Specification change of ACB

We would like to inform that we will change the specification for ACB.

AE4000-SW, AE5000-SW, AE6300-SW 4-pole type FN

Fig. 1. External appearance before and after the change

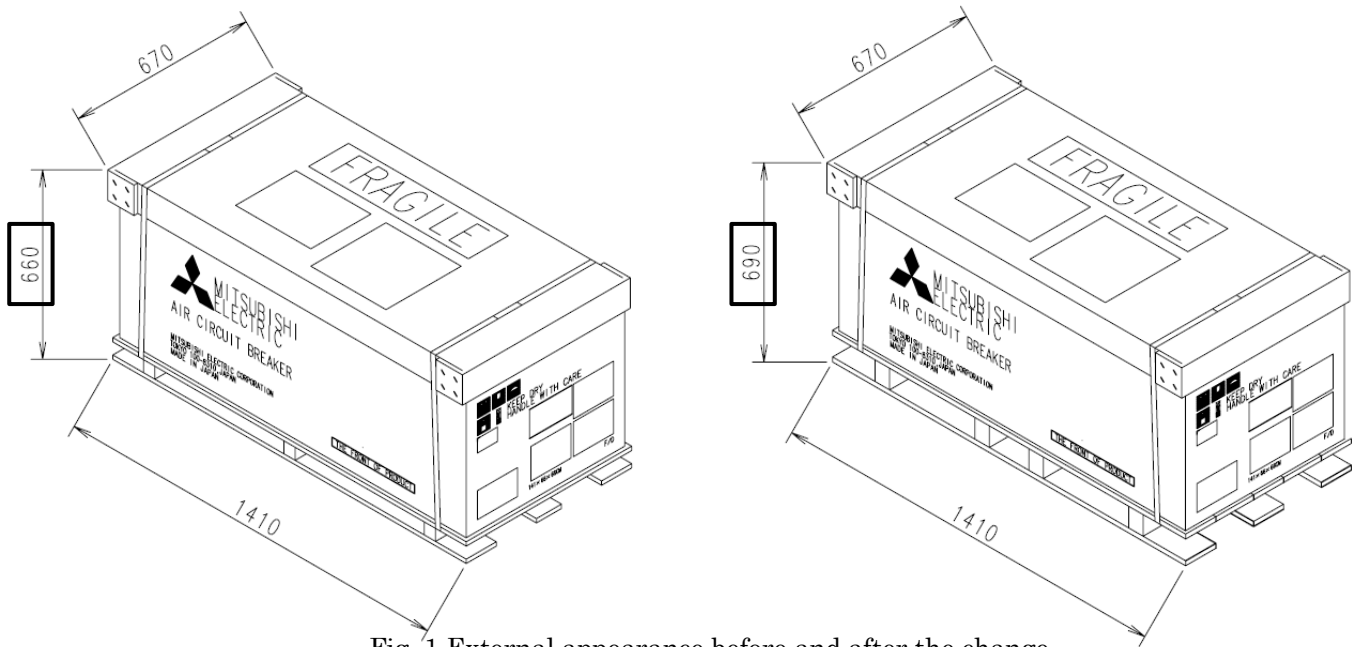
The height dimensions, number of digits, and materials of packing pallets have been changed, and the height dimensions after packing will be changed accordingly. (See below).

Before	After
(1)Height dimension after packing: 660mm	690mm (30mm UP). See photo below.
(2)Height dimension of pallet insertion slot: 45mm	75mm (30mm up) .Refer to the photo below and page 2 for detailed dimensions.
(3)Number of pallet digits: 3 places	4 places. See photo below, see page 2 for detailed dimensions.
(4)Pallet material: Plywood	Radiata pine. See photo below.
	<p>There is no change in the packing box.</p>
